Numark[®]

Service Information

CDX

Numark CDX Service Notes.

Title		
CDX Motor		
Size	Number	Revision
A4		
Date:	15-Jan-2004	Sheet of
File:		Drawn By:

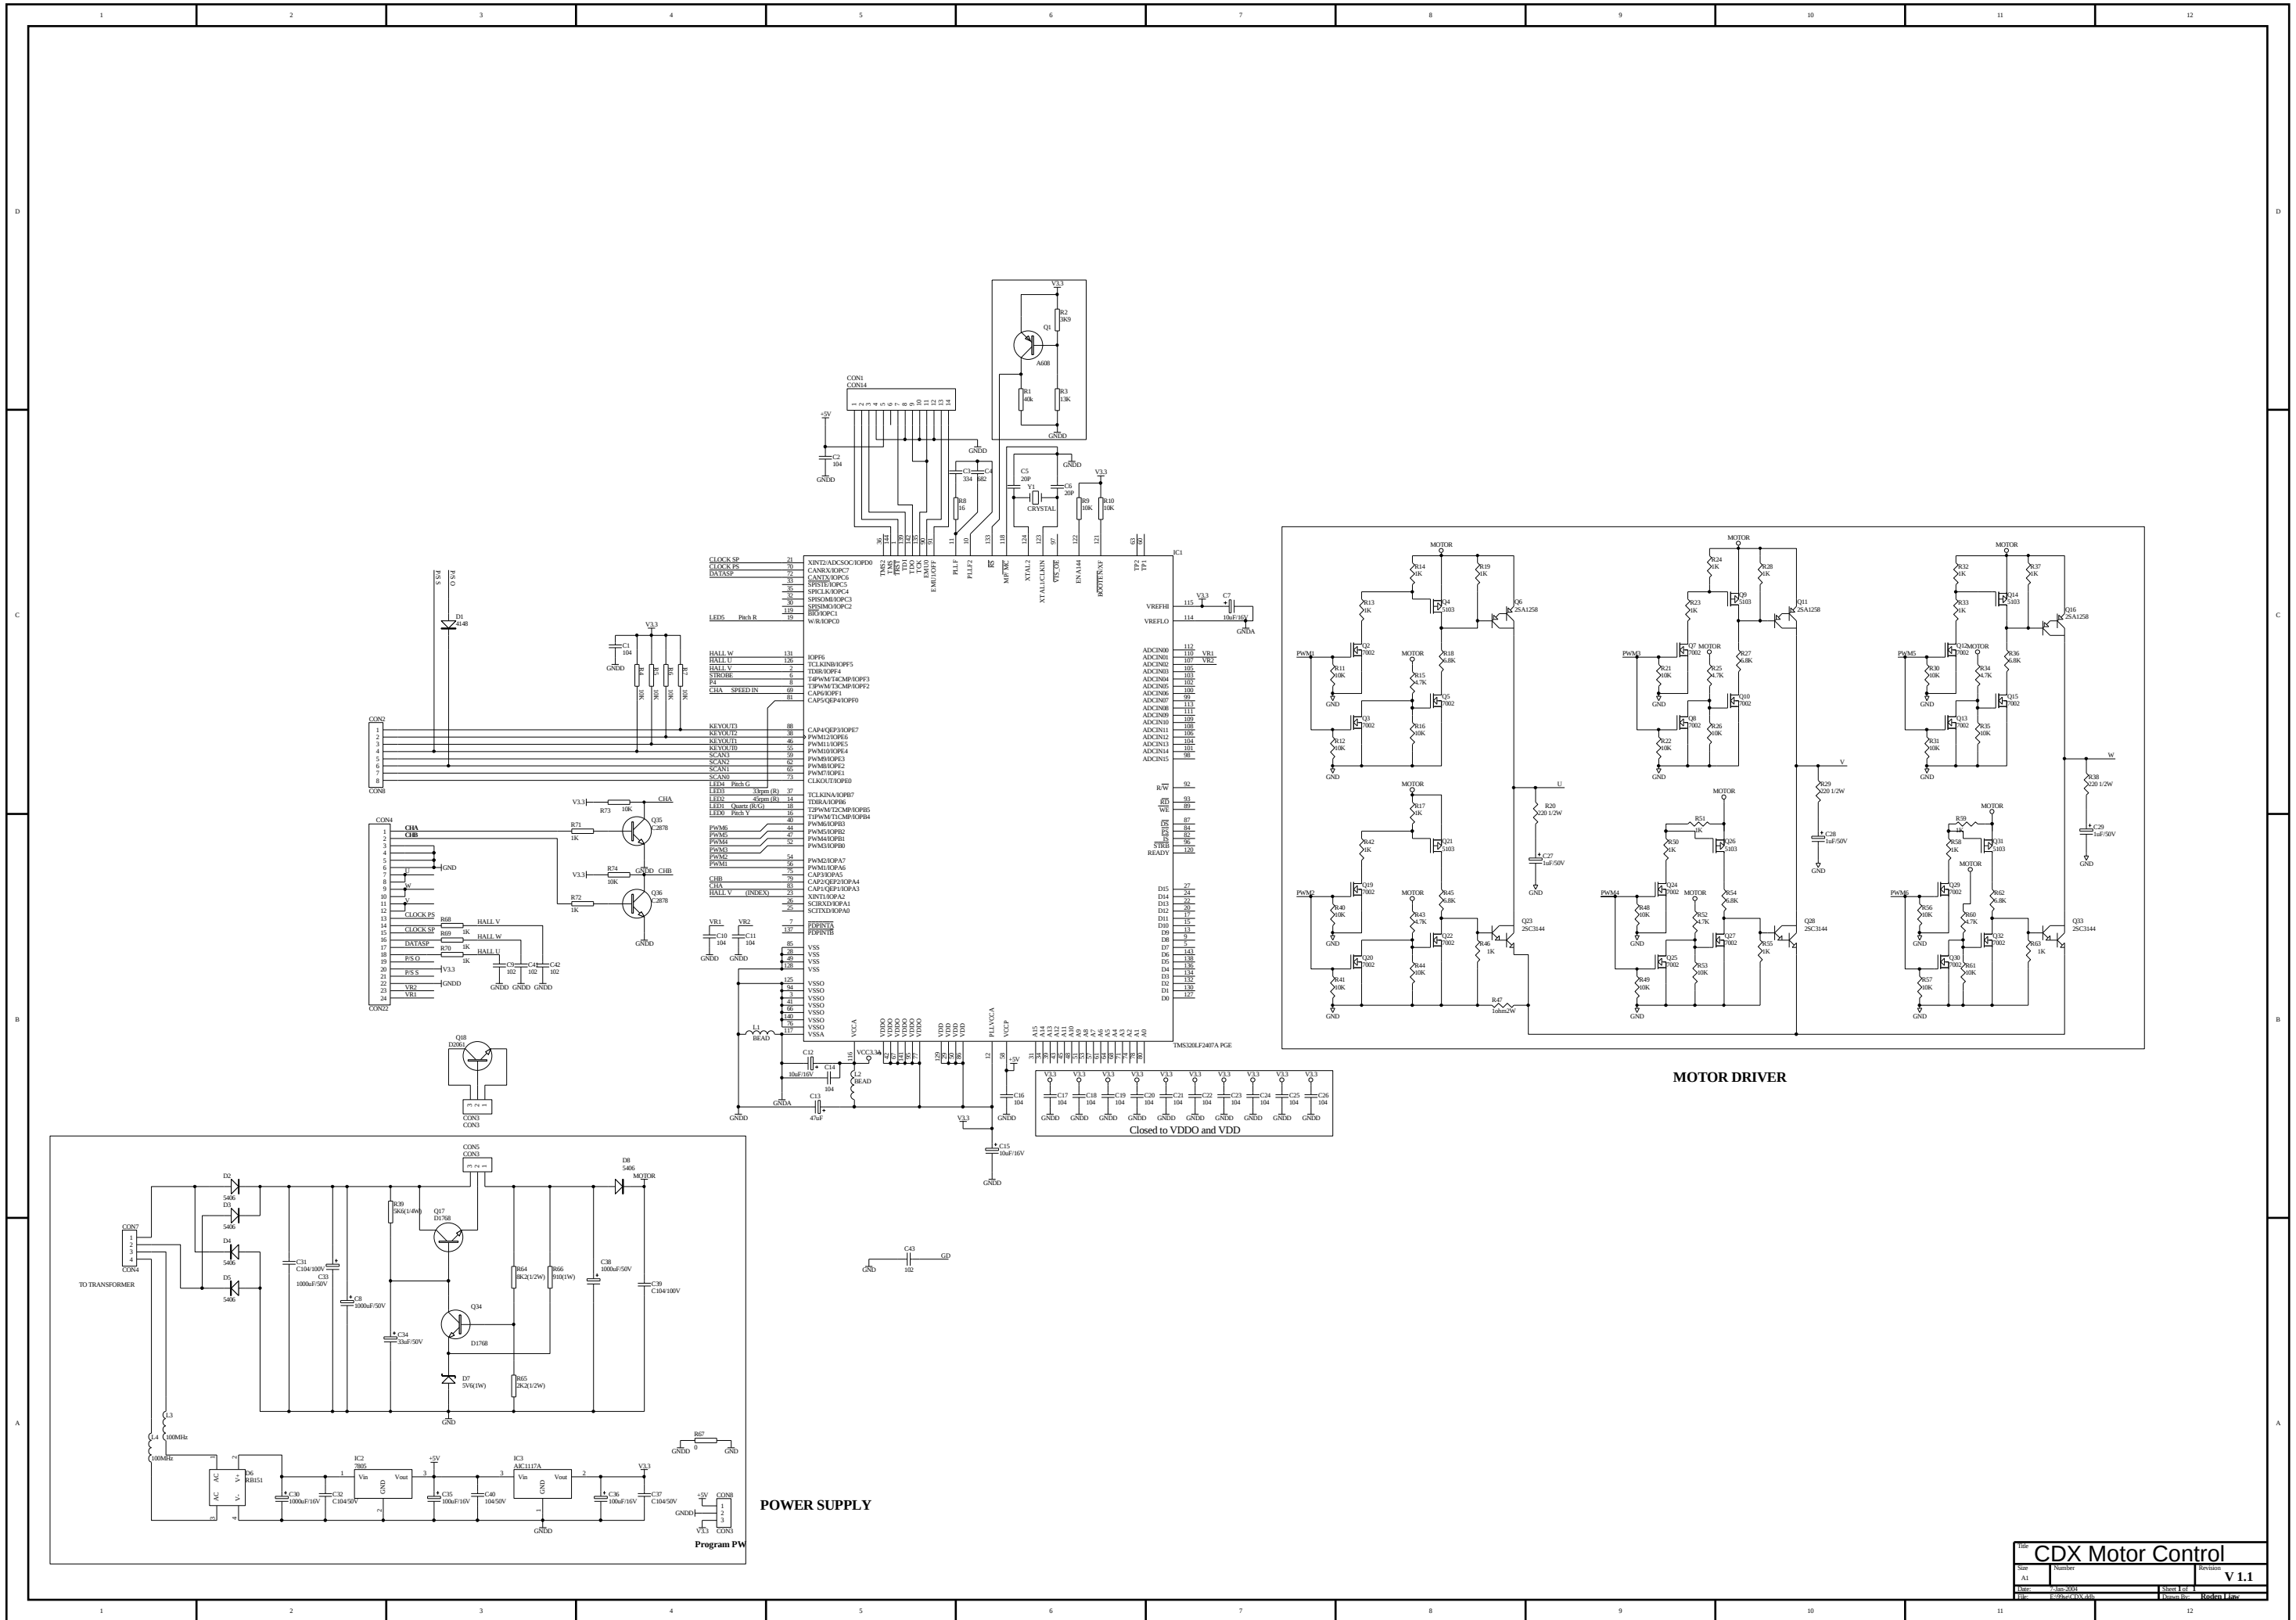
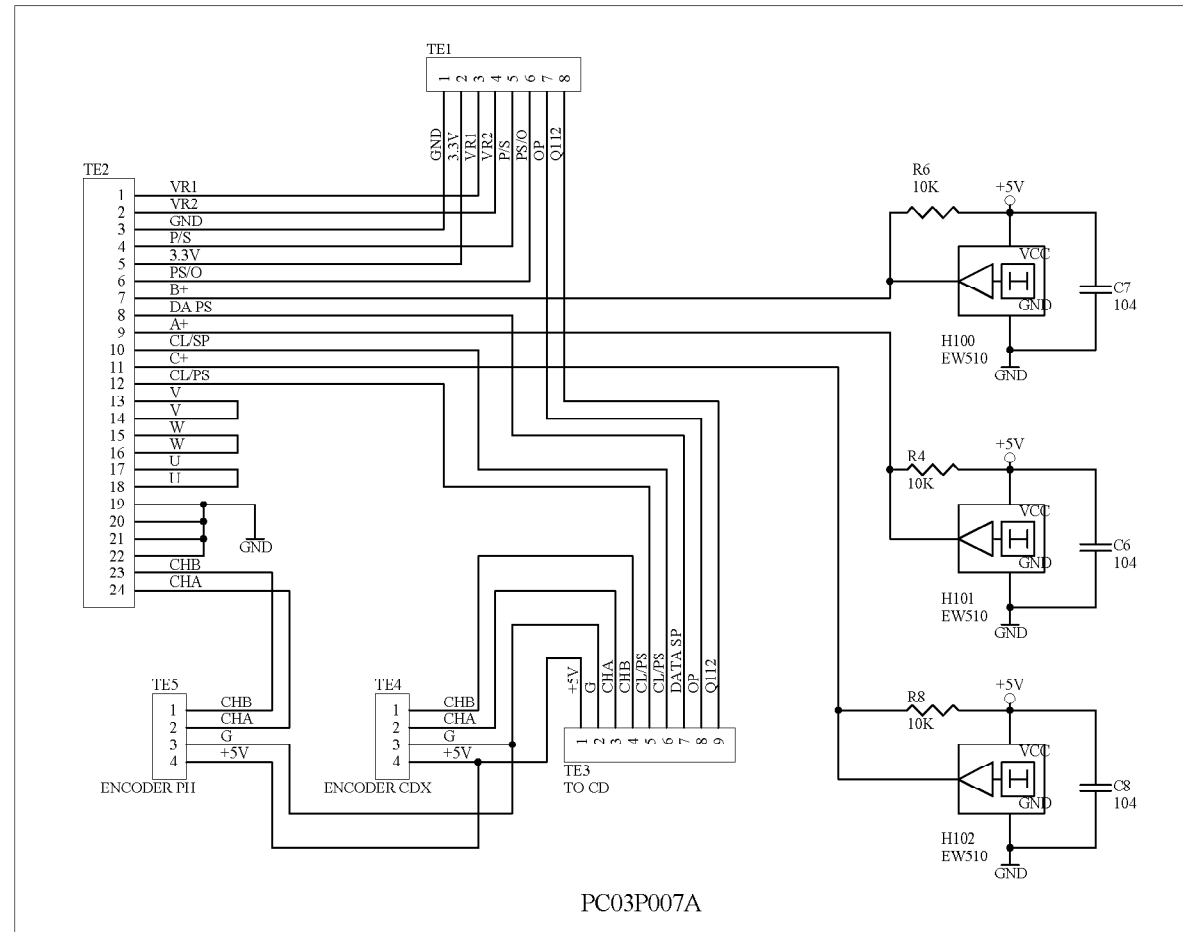
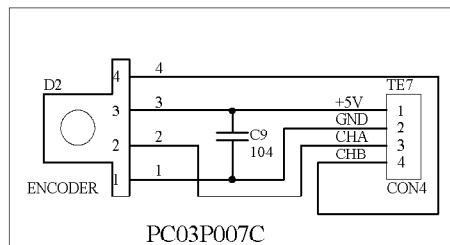
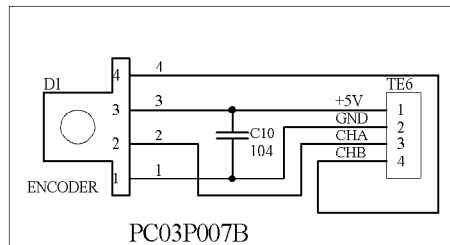
<u>TWPC03P006A01</u>	<u>PCB Assy, Motor Control</u>
ECN:NE23801	
Change R13,R23,R33,R42,R50 and R58 from 1K ohm to 3.9K ohm.	
This change was introduced to reduce possible failures of Mosfets Q4,Q9,Q14,Q21,Q26 and Q39 (IRML5103).	
ECN effective in production from serial No: (21)N10408551105081	
Aug 2004
